Stopnja zaščite, ki jo zagotavlja ohišje (koda IP) - Dopolnilo A2

EN 60529/A2

Degrees of protection provided by enclosures (IP Code)
(IEC 60529:1989/A2:2013)

AMENDMENT 2
AMENDEMENT 2

Figure 7 – Fan jet nozzle dimensions

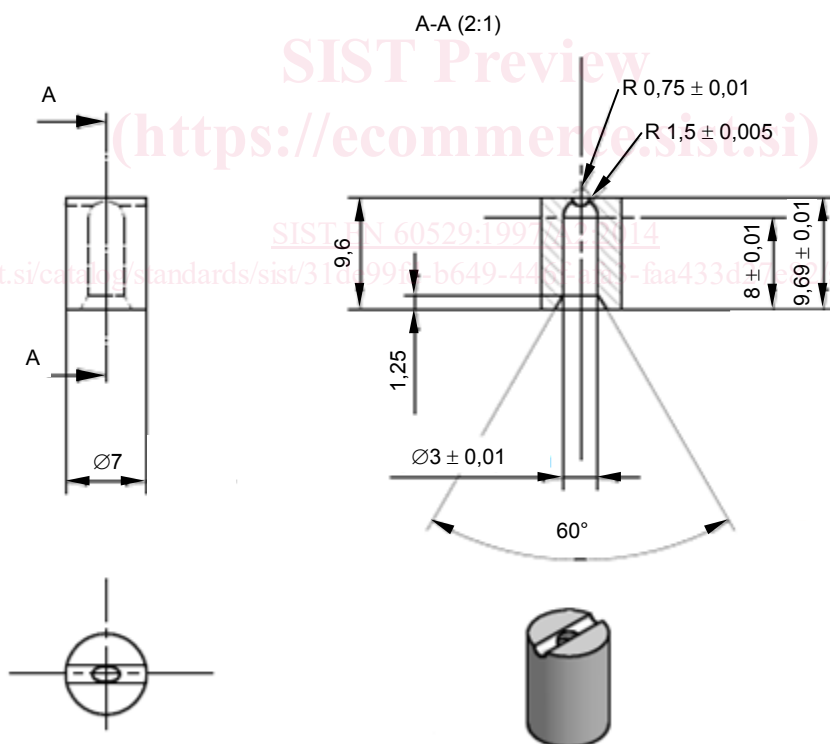
Add, after Figure 6, the following new figures:

The test is made by spraying the enclosure with a stream of water from a standard test nozzle as shown in Figures 7, 8 and 9.

NOTE The dimension $9,69 \pm 0,01$ refers to the centre of the radius $R0,75 \pm 0,01$.
